**CONTRACT ADDENDUM #**

**date:** 5.10.24  
**project:** Hyde Park Middle School  
**by:** Michael Rigby  
**subject:** Addendum 02

**HPMS ADDENDUM #2**

**SUBJECT:** **Addendum #2 – Changes to Bid Package #1**

**A**  
**S-113**

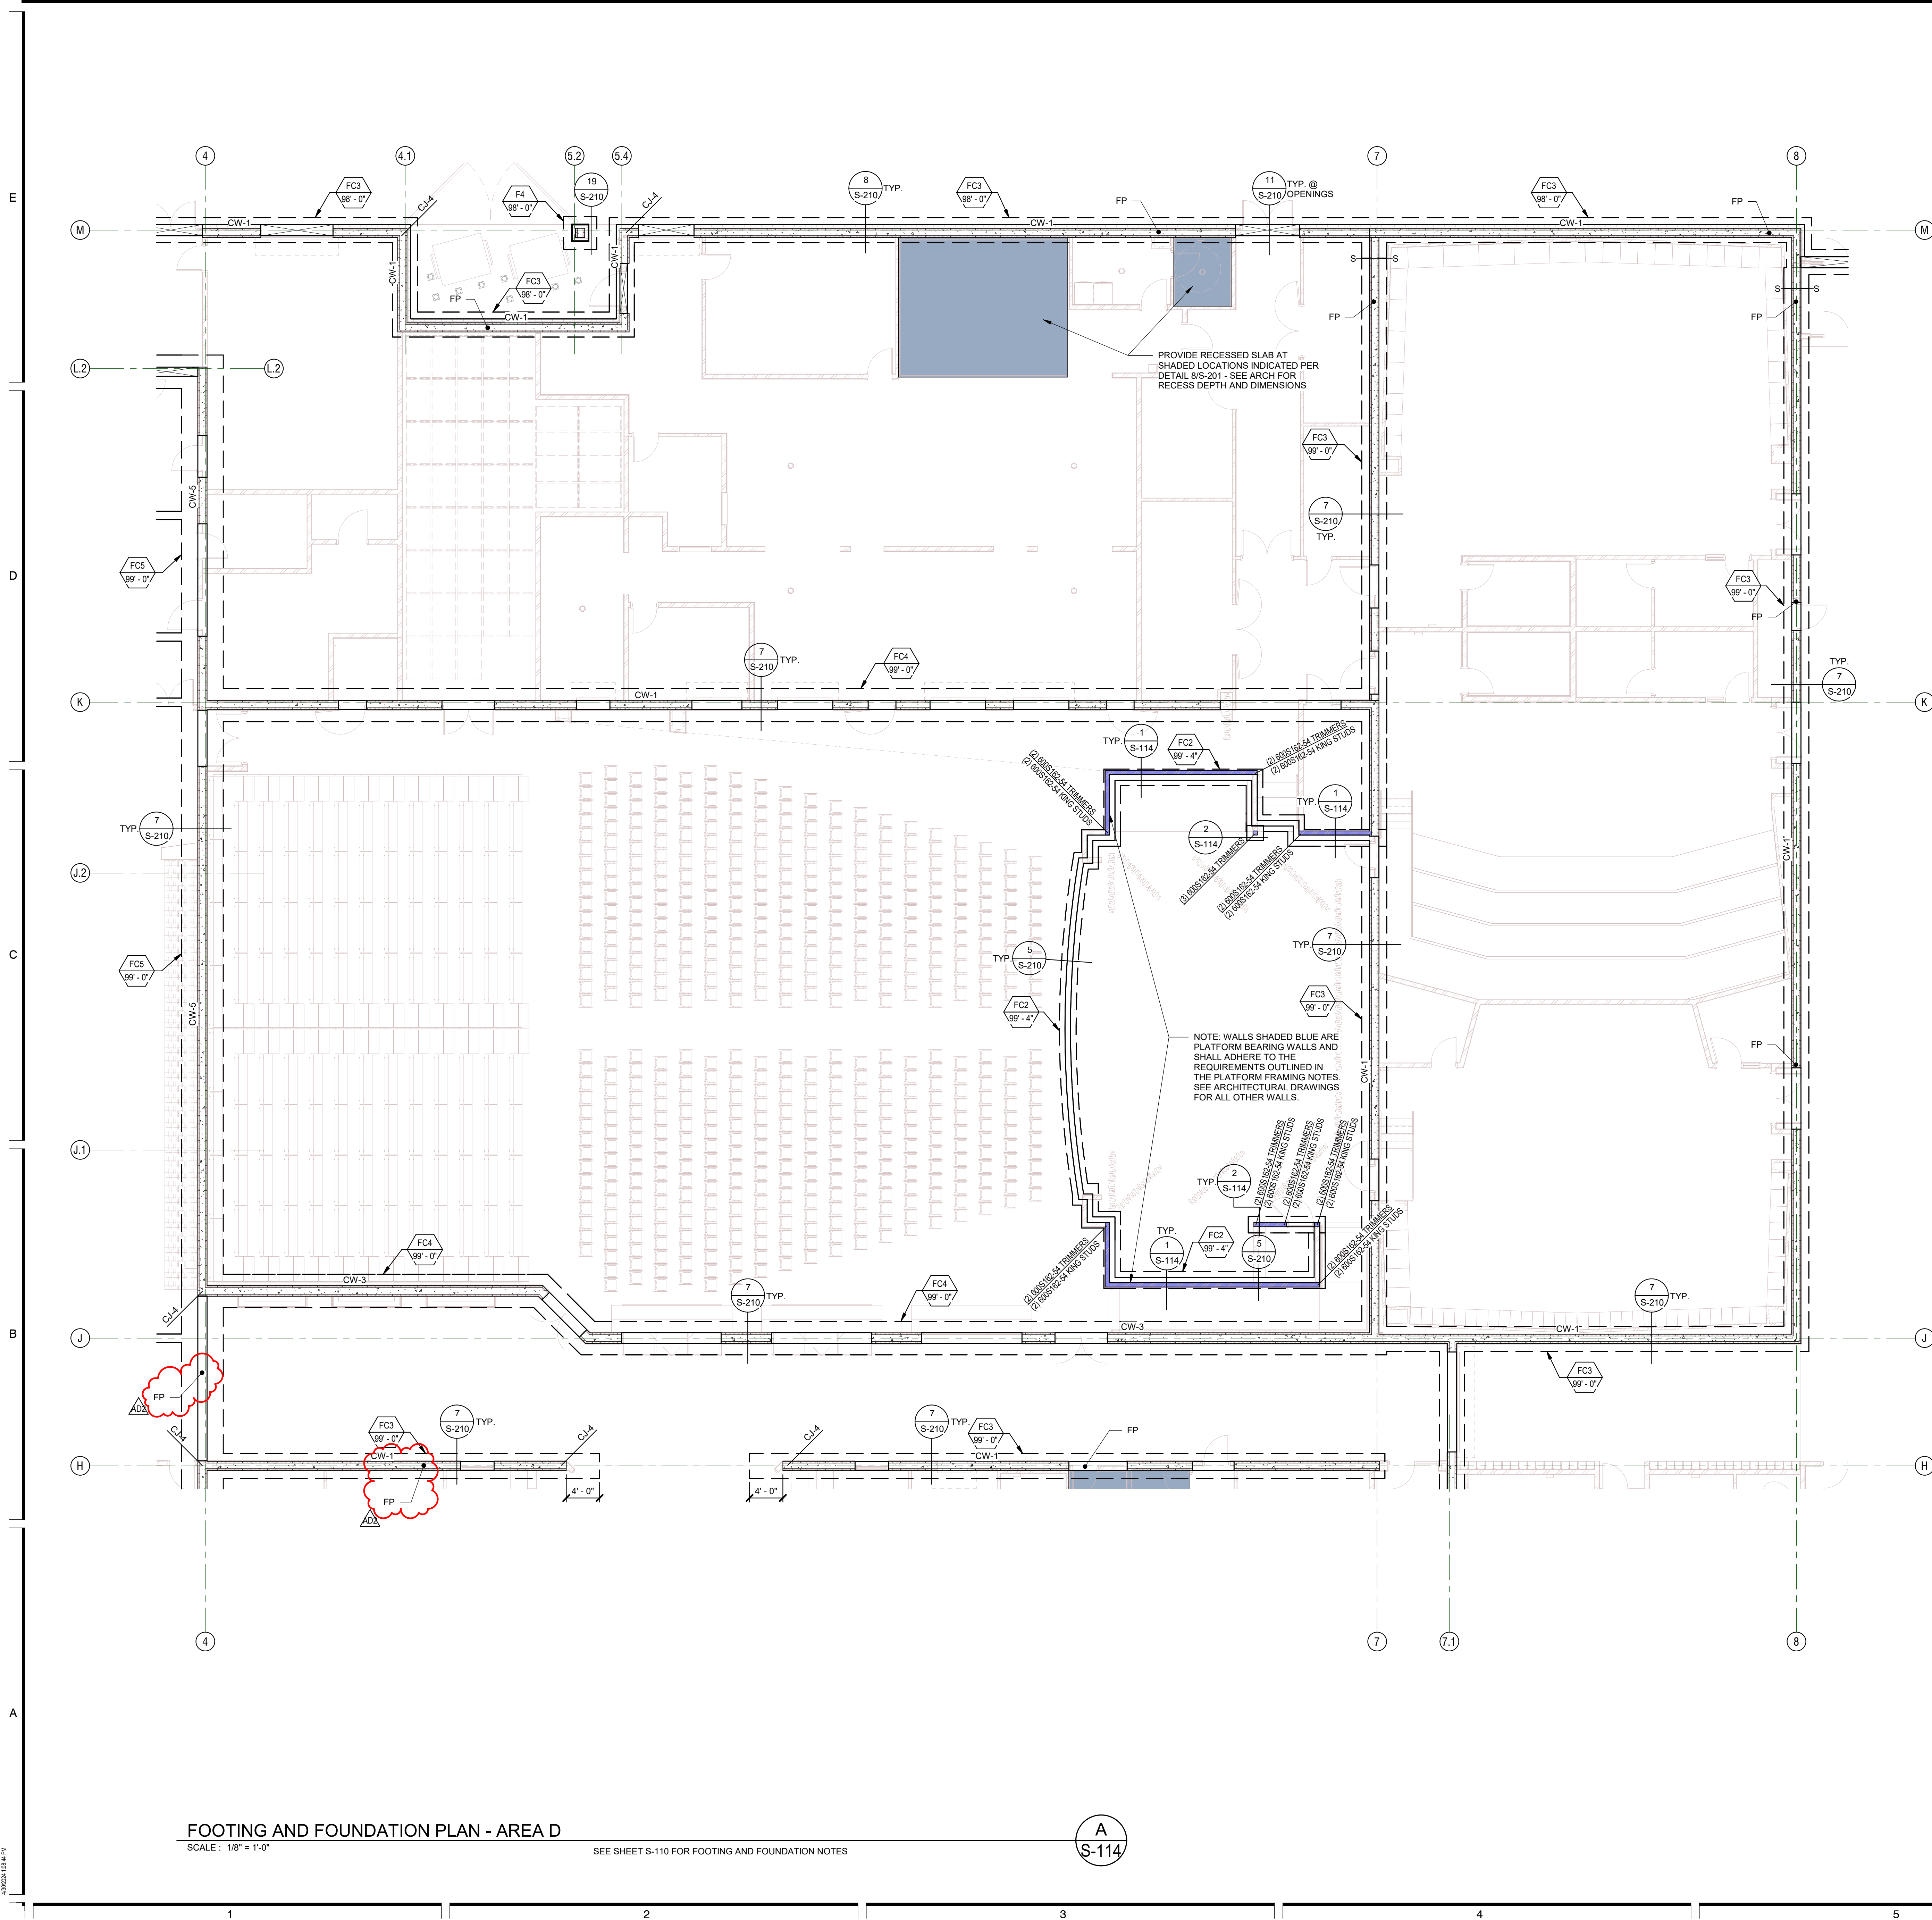
**Sheet S-113:**

- 1) The mechanical yard footings were revised.
- 2) Additional potential foundation penetrations ("FP") locations were noted.
- 3) Door location revisions have been shown.

**A**  
S-114

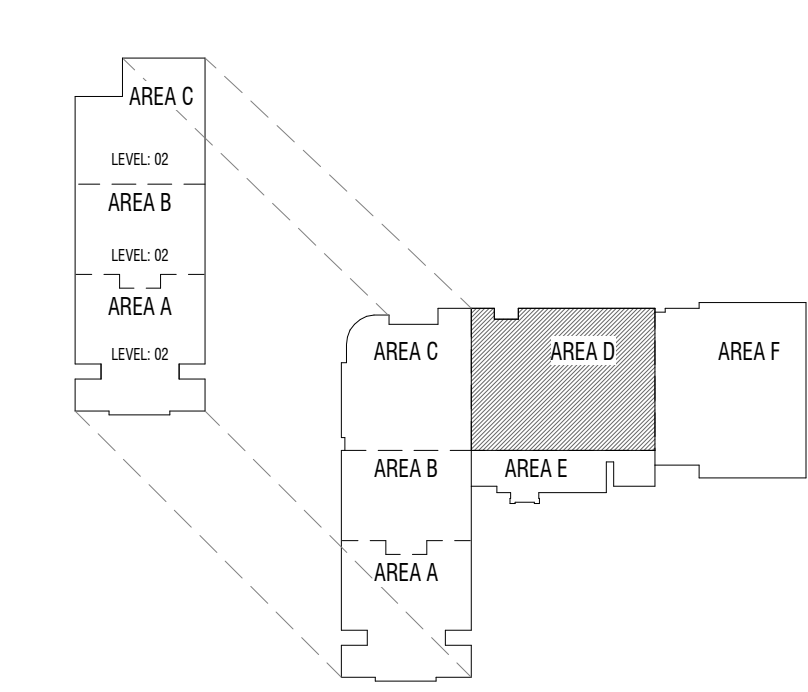
**Sheet S-114:**

- 1) Additional potential foundation penetrations ("FP") locations were noted.

**10** DETAIL  
SCALE: NONE

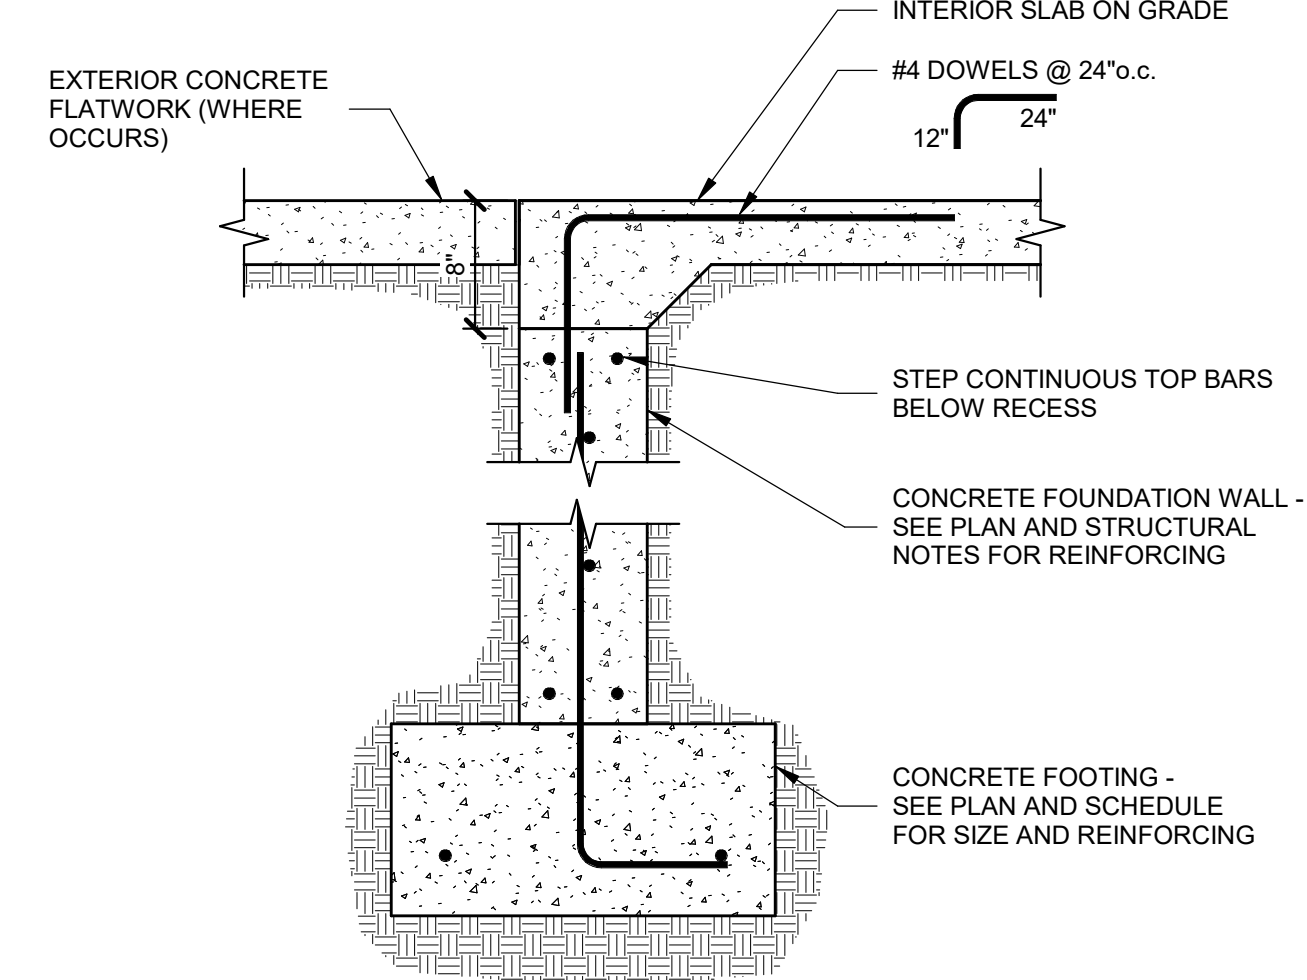
- 1) Detail 10 was revised to address changes to the screen wall around the mechanical yard.
